To: Facilities and Technology Committee
From: Bond Department
F&T Meeting Date: 01/06/2020
Project Description: Roosevelt ES Modular Classrooms

Change Order

Project: **Roosevelt Modular Classrooms**
951 Dowling Ave.
San Leandro, CA 94577

PCO #26 Additional Fence and Man Gate

FENCING PLAN | 1" = 30'-0" | 1

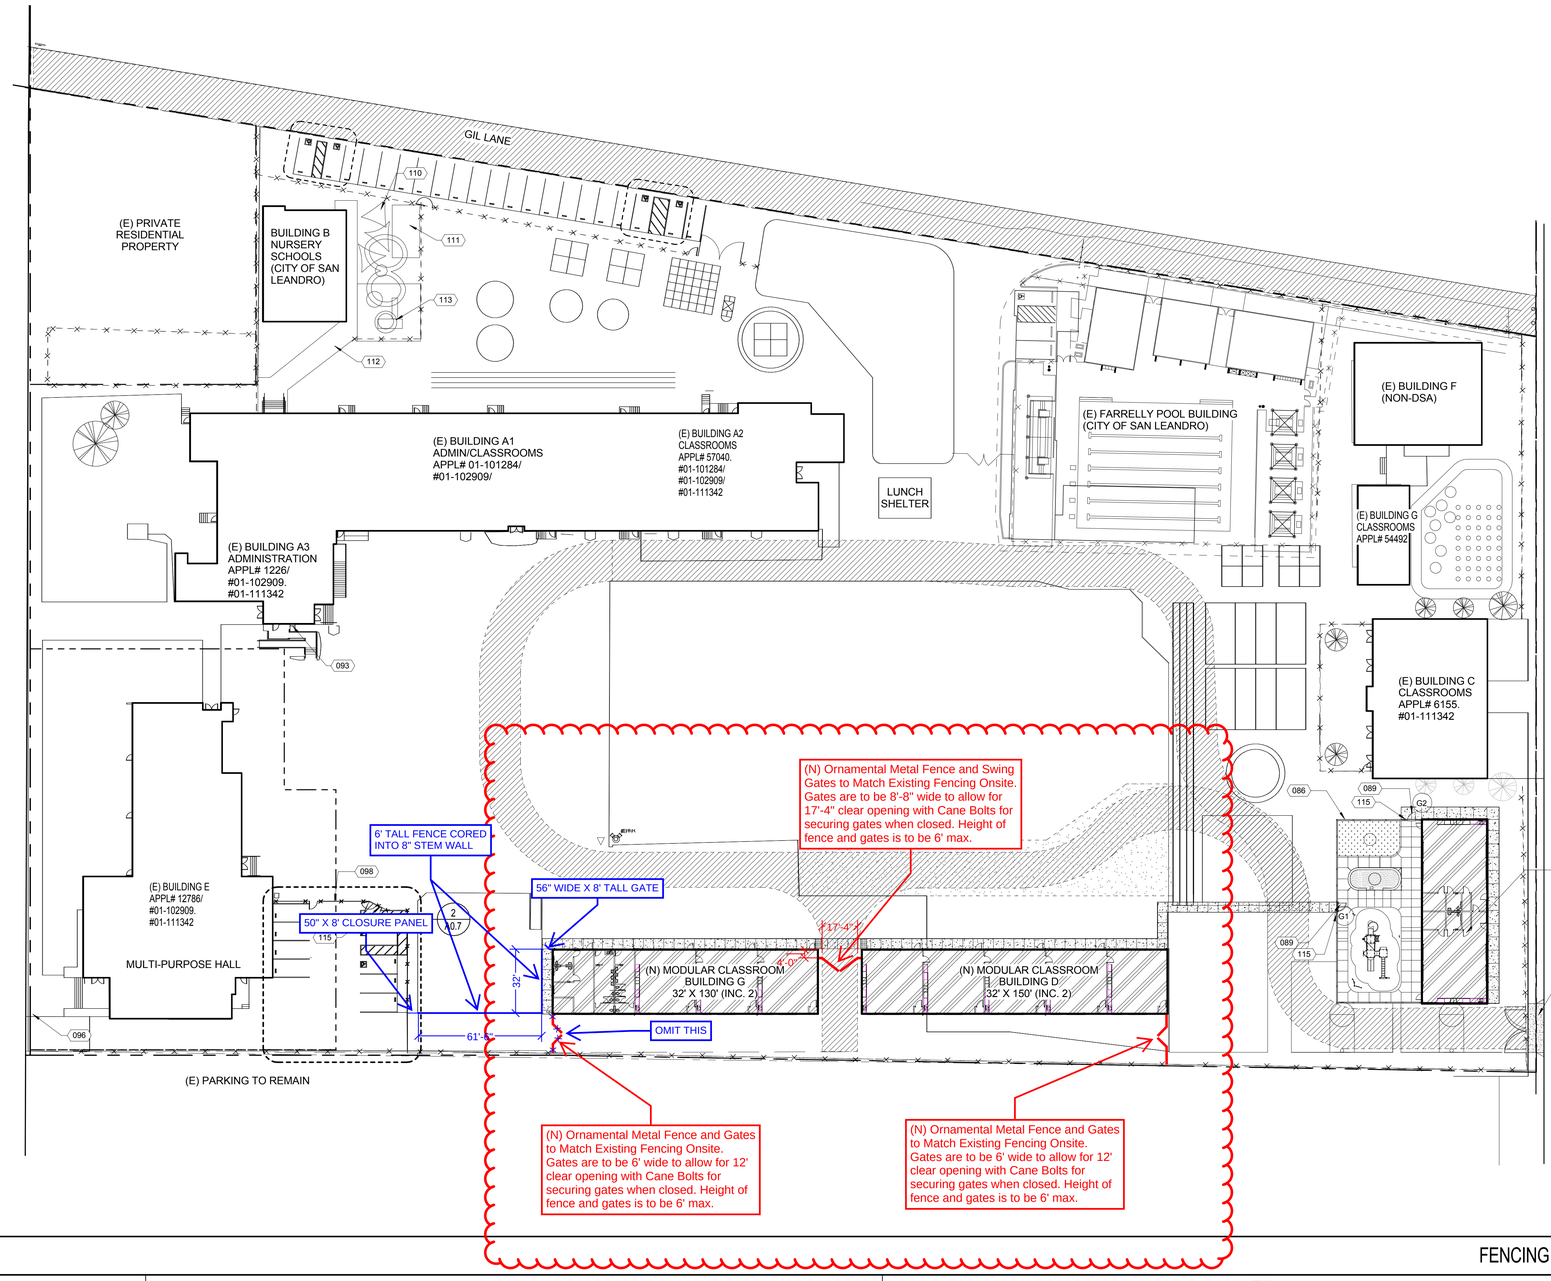
Costs associated with adding additional fencing and man gate at the South side of Building G. A new man gate will be installed at the sidewalk at the South end of Building G and fencing will be installed on top of the stem wall at two (2) sides of the existing playground (see attached sketch). Pricing includes a credit for one (1) of the swing gates approved in CP 022.

NEW WORK - Core drill and grout set 2 new 4" sq gate posts in the walkway and 12 new 3" sq fence posts on the top of the walls and dig and set 1 new 3" sq fence post at the end of the wall by the existing 8' high chain link fence Install 12 new 6' high Ameristar Montage II Genesis 3 Rail Fence panels on top of the wall and 1 new 8' high fence panel at the end of the wall by the chain link fence. Install one new 42" wide x 8' high single swing Panic Hardware gate with Mammoth 180 hinge set
Eliminate the following work from Change Order #2 - Eliminate 2 gate posts and 2 end posts and 1 fence panel and 1 fixed end panel and one 13' wide double swing gate, the fittings associated with the panels and gate and the concrete footings

GATE ELEVATION WITH PANIC HARDWARE | 1/2" = 1'-0" | 2

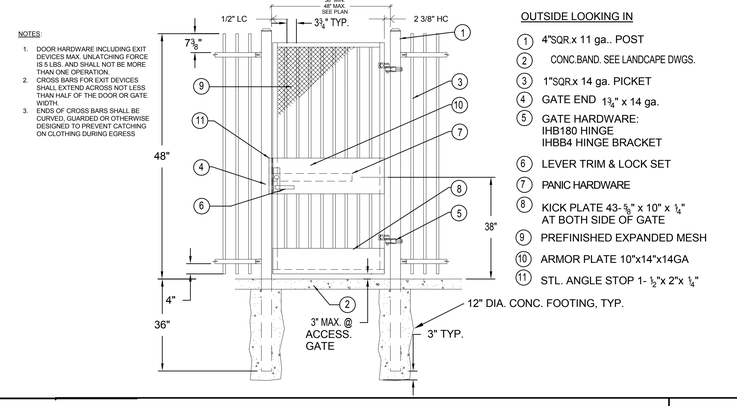
NEW MATERIALS - $ 14,084.36 CREDITED MATERIALS - ($ 4,638.00)
NEW CONCRETE AND GROUT - $ 258.00 CREDITED CONCRETE - ($ 68.00)
NEW FIELD LABOR FOR THE NEW WORK - 4 DAYS 2 MEN - $ 7,800.00
CREDITED LABOR FOR ELIMINATED WORK - 2 MEN 1 DAY - ($ 1,950.00)
SHOP LABOR FOR THE PANIC HARDWARE GATE - $ 1,140.00
SHOP LABOR ELIMINATED FOR THE 1 FIXED PANEL - ($ 190.00)
CORE DRILL RENTAL - $ 350.00
